URGENT: MEDICAL DEVICE CORRECTION

Olympus EVIS EXERA III GASTROINTESTINAL VIDEOSCOPE

Catalog number	Serial Number Range	UDI-DI
GIF-1TH190	Before 2446103 and After 2500453	04953170343360 04953170437014

4. (1st port) Hold the control section, and aerate the suction cylinder, as follows:

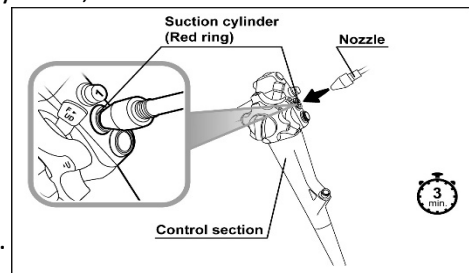
- a) Start the timer. (3 minutes)
- b) Push the nozzle straight into the suction cylinder and blow.
- c) Keep blowing until the timer alarm beeps.

5. (2nd port) Hold the control section, and aerate the air/water cylinder, as follows:

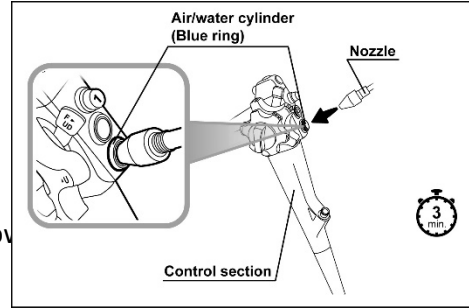
- a) Start the timer. (3 minutes)
- b) Push the nozzle straight into the air/water cylinder and blow
- c) Keep blowing until the timer alarm beeps.

6. (3rd port) Hold the endoscope connector, and aerate the auxiliary water inlet, as follows:

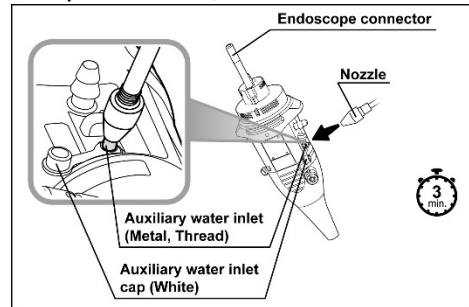
- a) Start the timer. (3 minutes)
- b) Push the nozzle tip straight into the auxiliary water inlet to minimize air leaks and blow air.
- c) Keep blowing until the timer alarm beeps.

7. (4th port) Hold the control section, and aerate the instrument channel port, as follows:

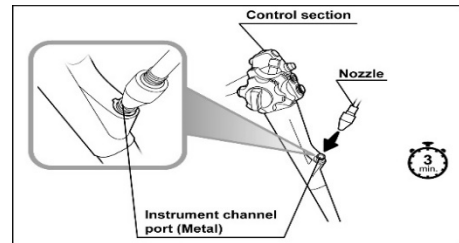
- a) Start the timer. (3 minutes)
- b) Push the nozzle straight into the instrument channel port and blow.
- c) Keep blowing until the timer alarm beeps.

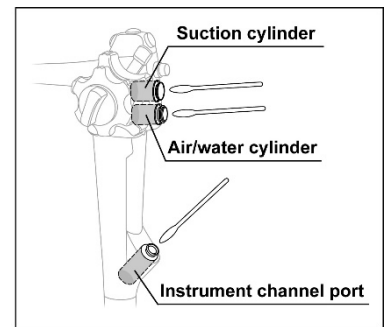
8. Thoroughly dry the inside of the suction cylinder, the air/water cylinder, and the instrument channel port of the endoscope, using sterile cotton swabs.

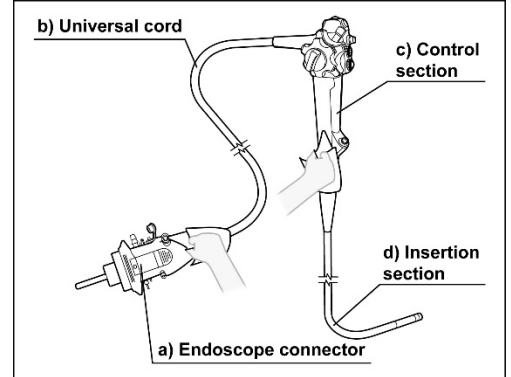
9. Wipe all of the following external surfaces of the endoscope with a sterile lint-free cloth until they are thoroughly dry.

- a) Endoscope connector
- b) Universal cord
- c) Control section
- d) Insertion section
